7 March 2025

Our Ref: P222_481-1 (ACCESS DA) DV

**ACCESSIBILITY CAPABILITY STATEMENT FOR SSDA SUBMISSION
PROJECT NAME: 3-5 HELP STREET, CHATSWOOD**

Drawing No.
 SSSA-1004

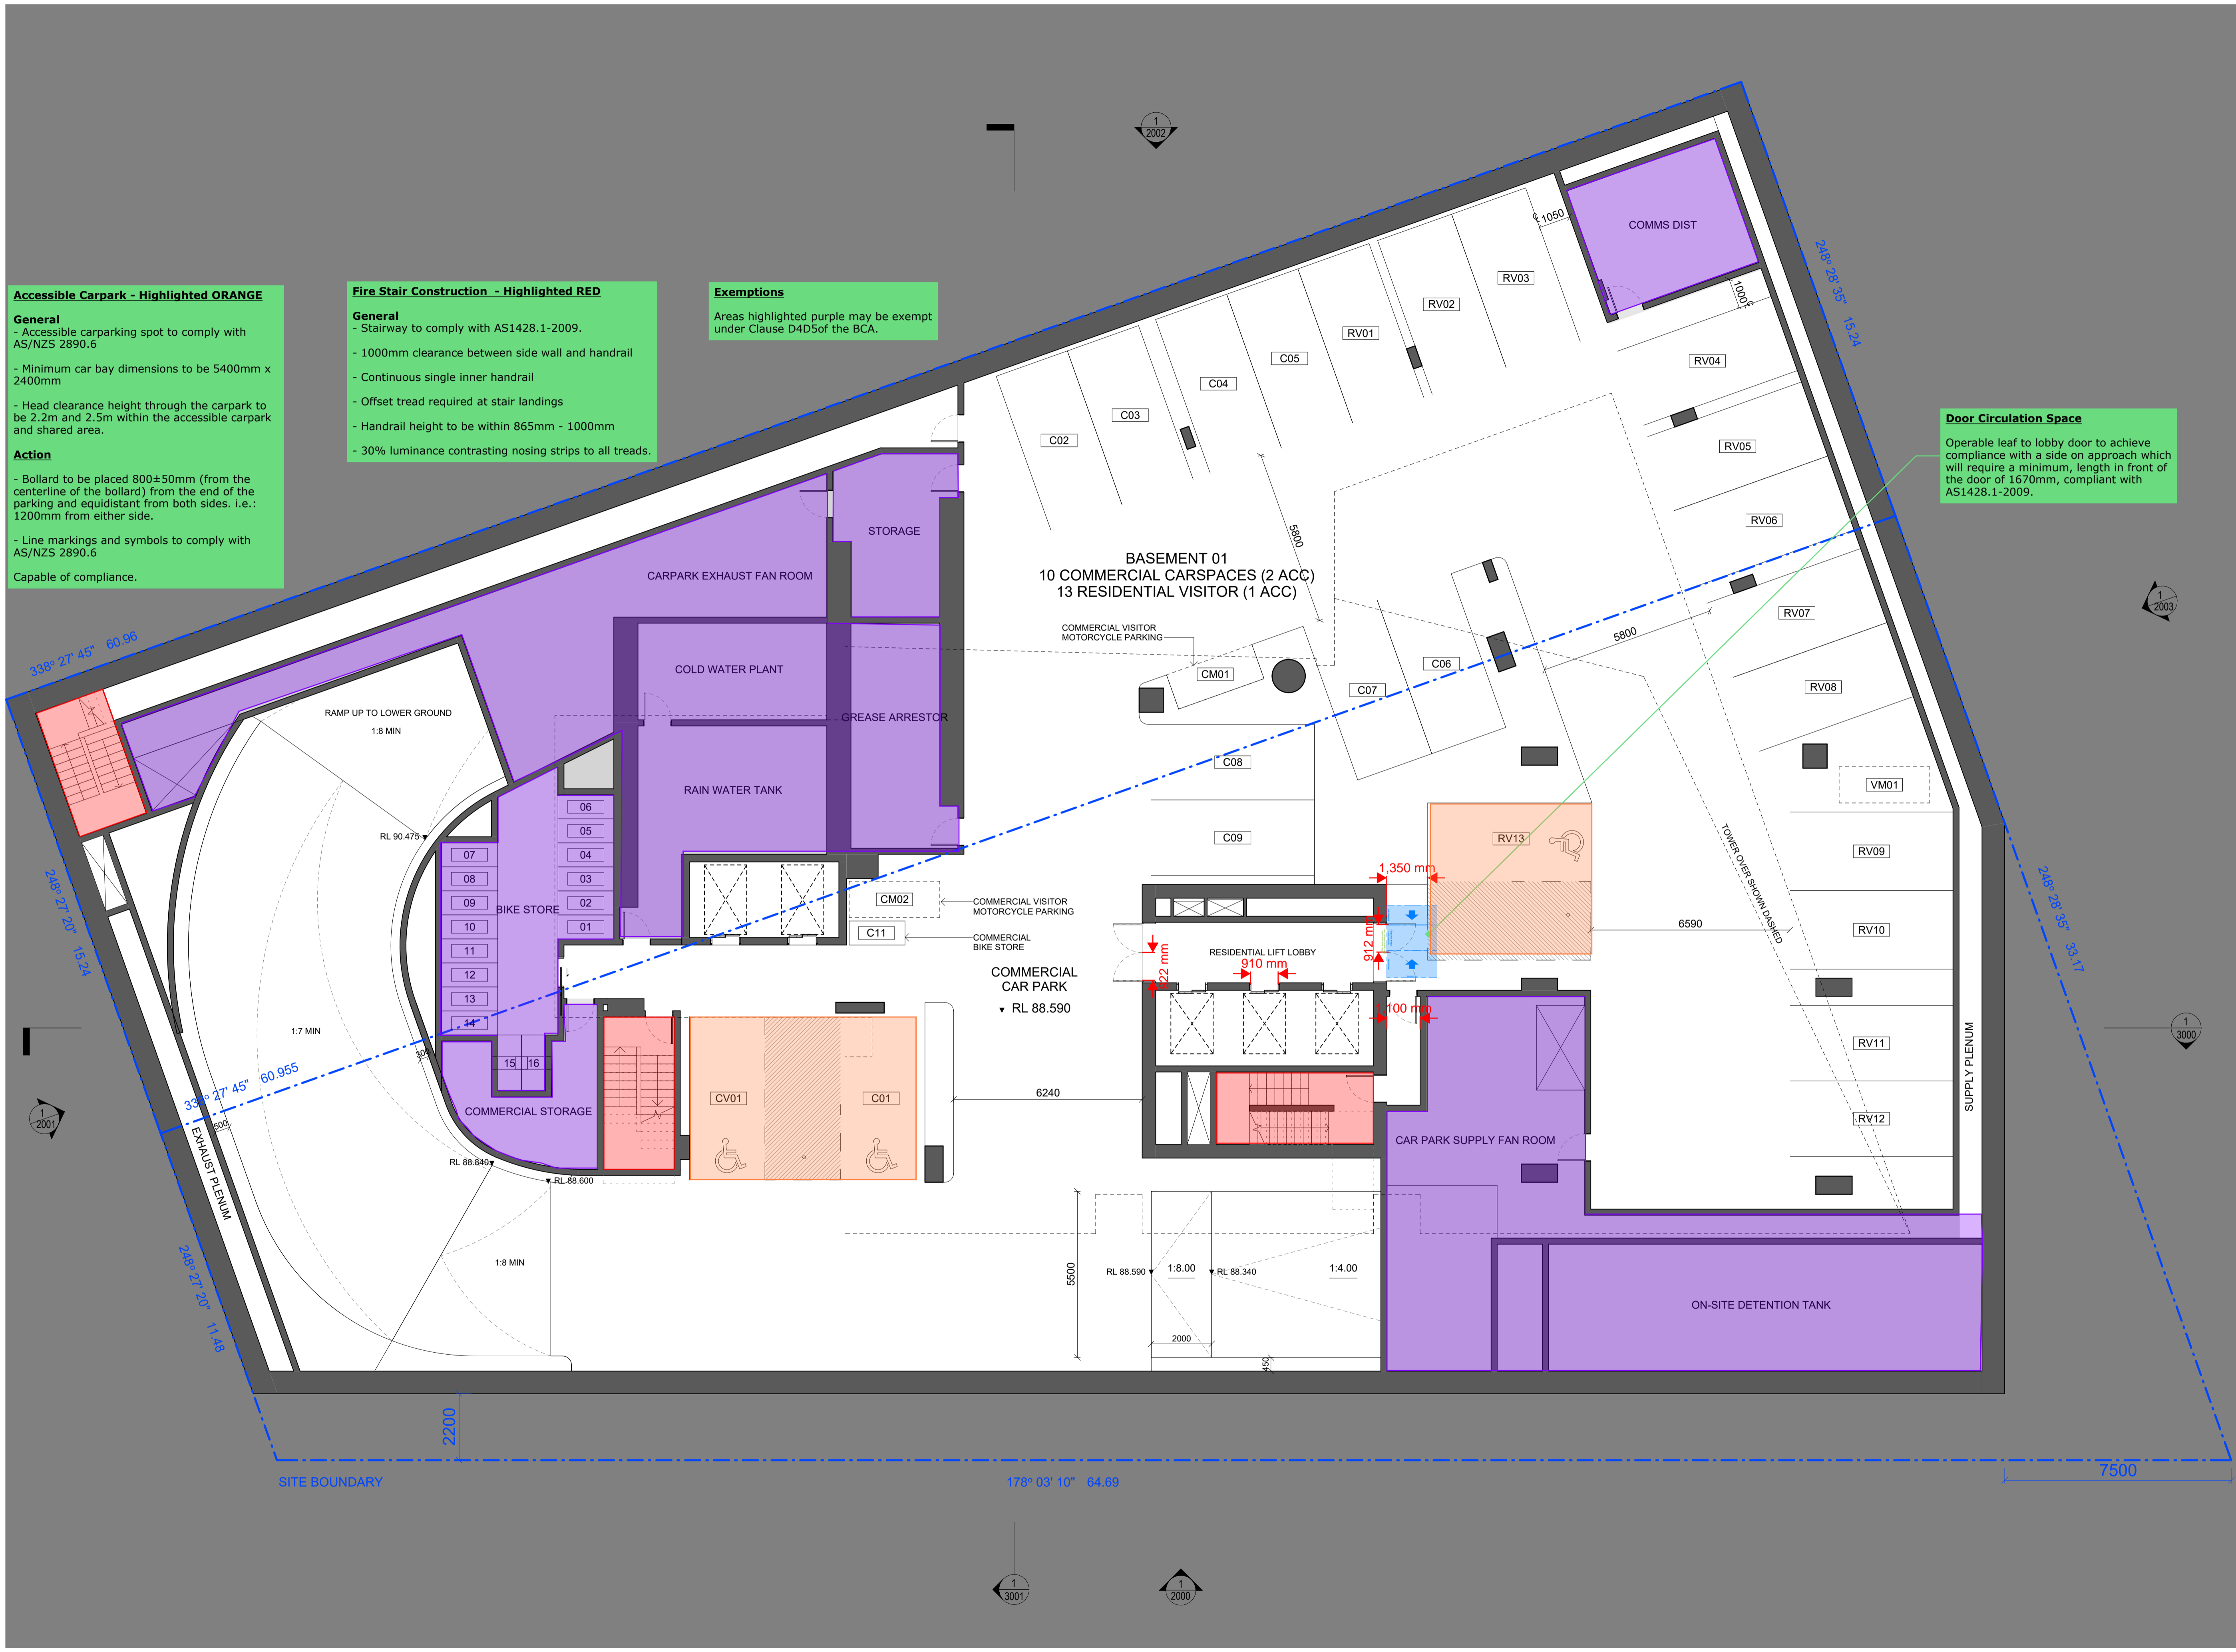
- Accessible carparking spot to comply with AS/NZS 2890.6
- Minimum car bay dimensions to be 5400mm x 2400mm
- Head clearance height through the carpark to be 2.2m and 2.5m within the accessible carpark and shared area.

- Bollard to be placed 800±50mm (from the centerline of the bollard) from the end of the parking and equidistant from both sides, i.e.: 1200mm from either side.
- Line markings and symbols to comply with AS/NZS 2890.6

- Stairway to comply with AS1428.1-2009.
- 1000mm clearance between side wall and handrail
- Continuous single inner handrail
- Offset tread required at stair landings
- Handrail height to be within 865mm - 1000mm
- 30% luminance contrasting nosing strips to all treads.

Operable leaf to lobby door to achieve compliance with a side on approach which will require a minimum, length in front of the door of 1670mm, compliant with AS1428.1-2009.

Drawing No.
SSDA-1100

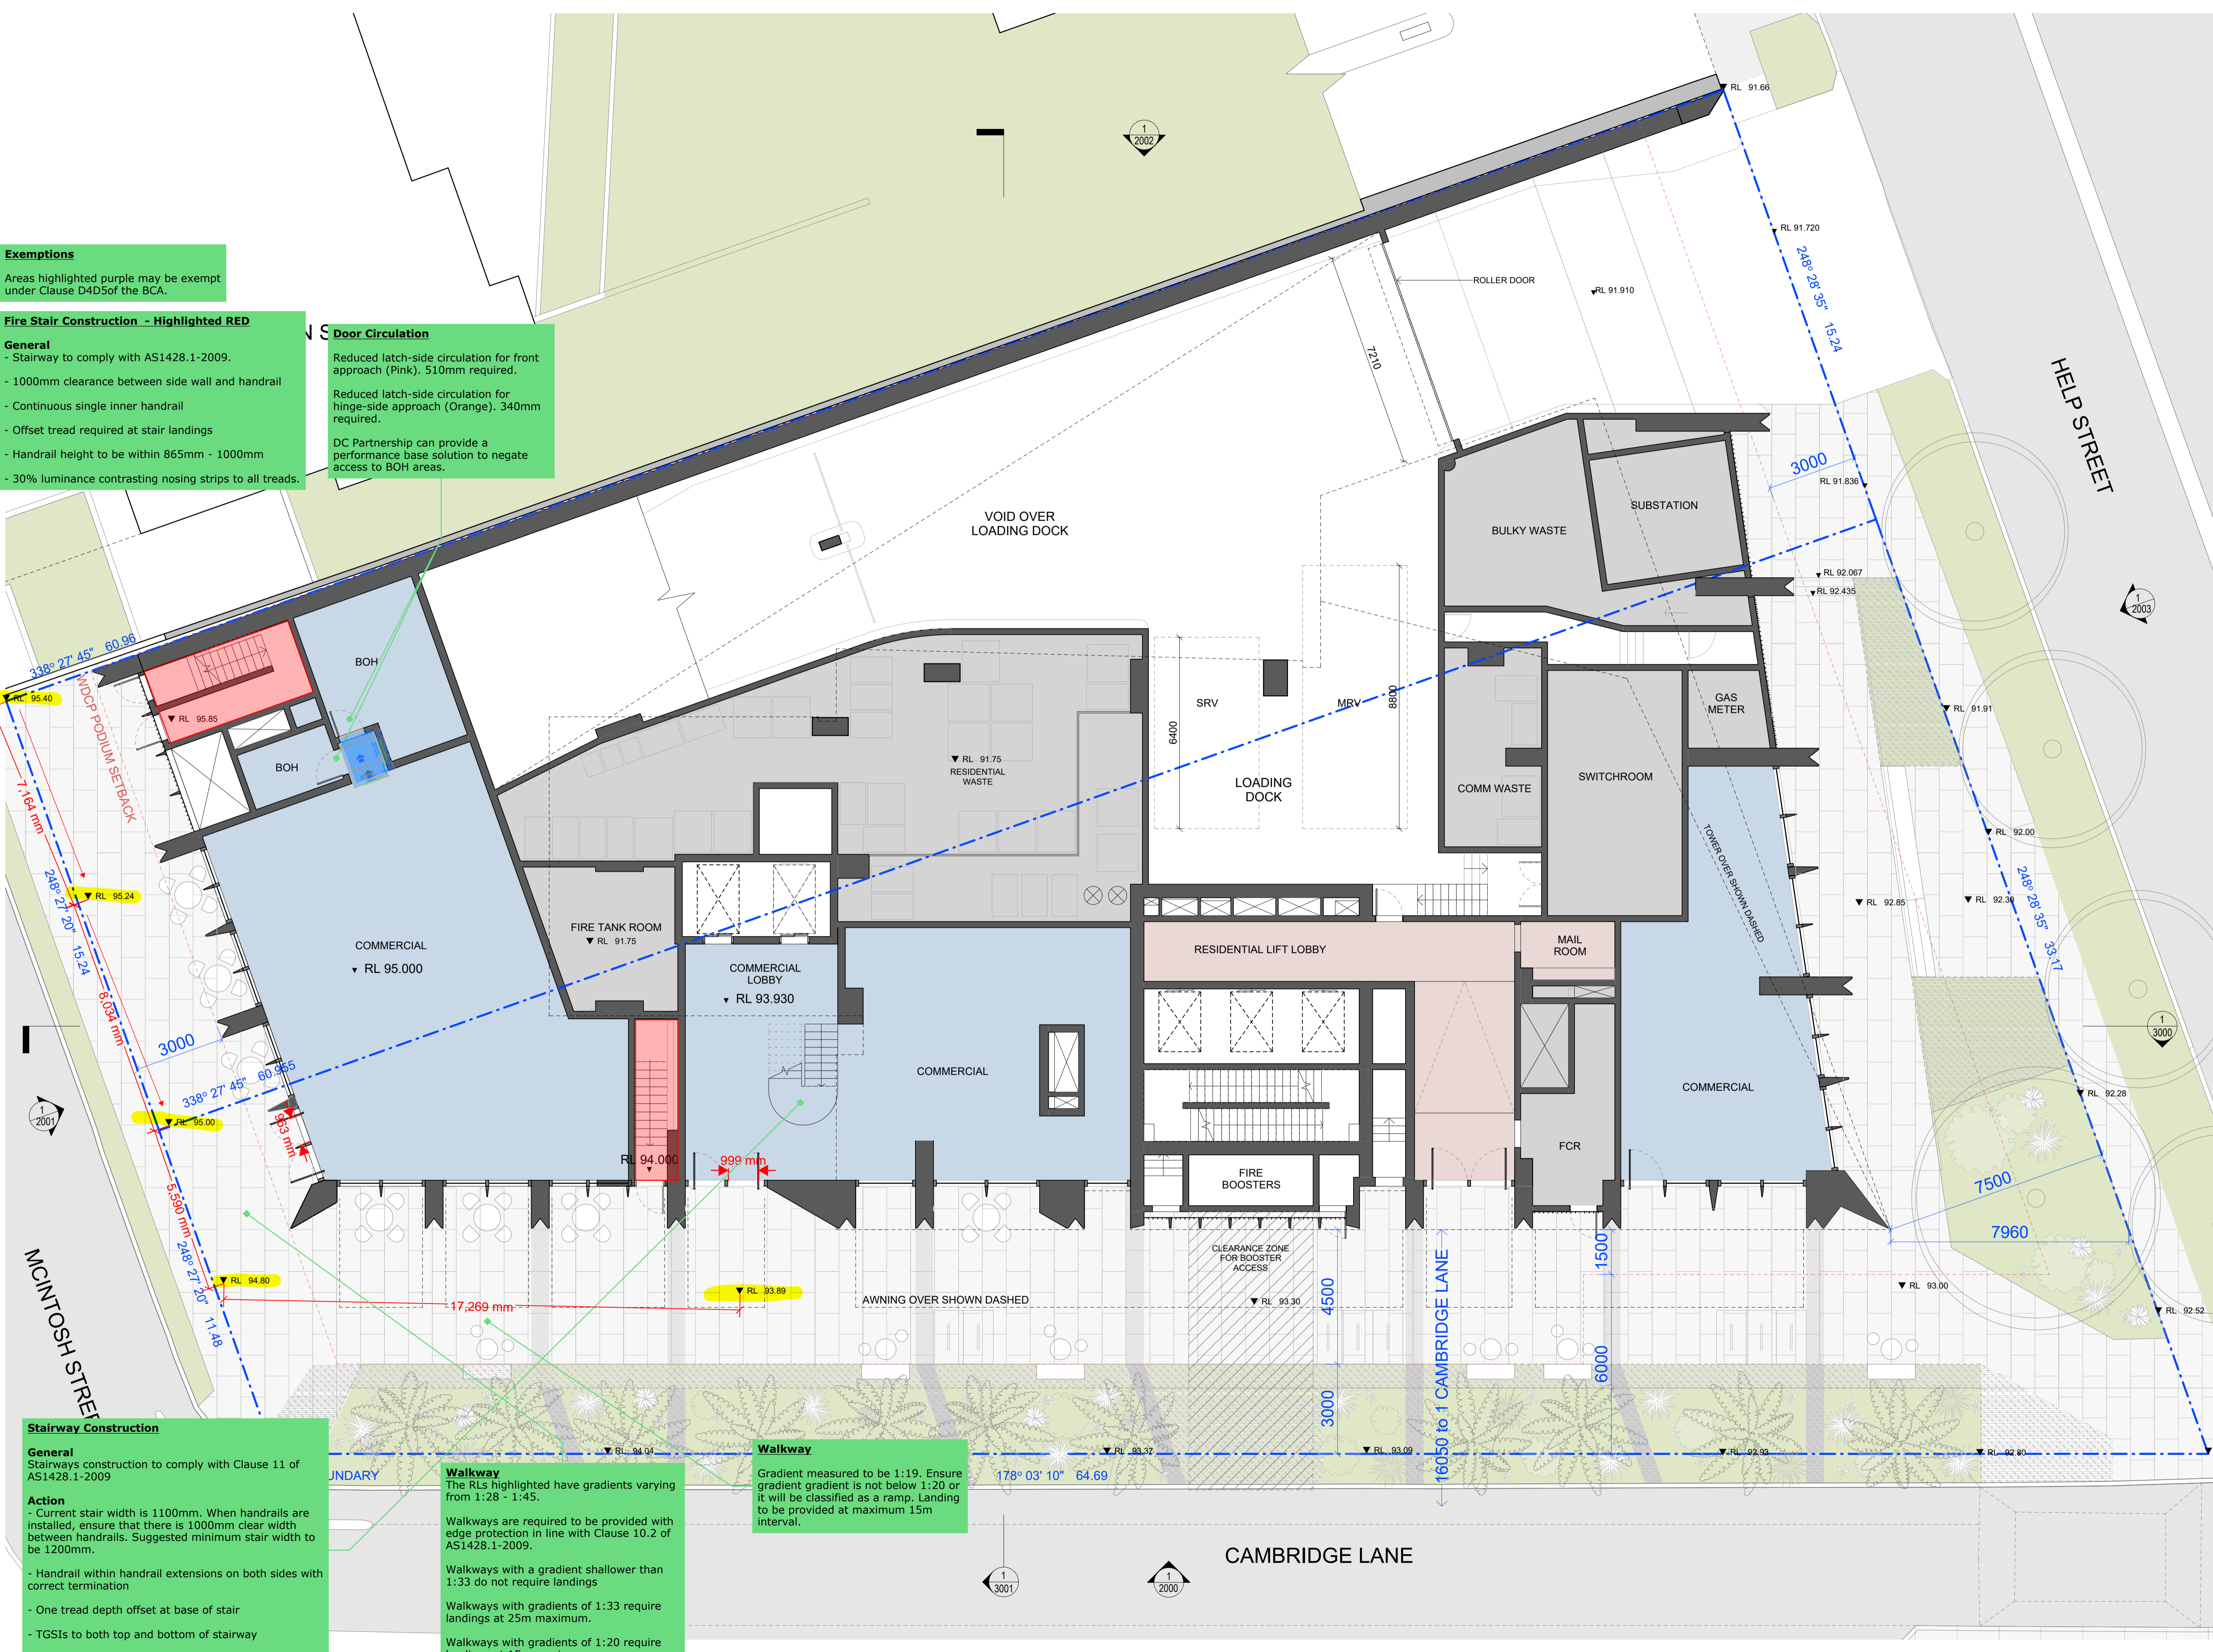
Door Circulation
 Reduced latch-side circulation for front approach (Pink). 510mm required.
 Reduced latch-side circulation for hinge-side approach (Orange). 340mm required.
 DC Partnership can provide a performance base solution to negate access to BOH areas.

Stairway Construction
General
 Stairways construction to comply with Clause 11 of AS1428.1-2009
Action
 - Current stair width is 1100mm. When handrails are installed, ensure that there is 1000mm clear width between handrails. Suggested minimum stair width to be 1200mm.
 - Handrail within handrail extensions on both sides with correct termination
 - One tread depth offset at base of stair
 - TGSIs to both top and bottom of stairway
 - Nosing strips with 30% luminance contrast to be provided to all treads.

Walkway
 The RLs highlighted have gradients varying from 1:28 - 1:45.
 Walkways are required to be provided with edge protection in line with Clause 10.2 of AS1428.1-2009.
 Walkways with a gradient shallower than 1:33 do not require landings
 Walkways with gradients of 1:33 require landings at 25m maximum.
 Walkways with gradients of 1:20 require landings at 15m maximum
 Walkways with a gradient between 1:20 - 1:33 require landings determined by linear interpolation.

Walkway
 Gradient measured to be 1:19. Ensure gradient gradient is not below 1:20 or it will be classified as a ramp. Landing to be provided at maximum 15m interval.
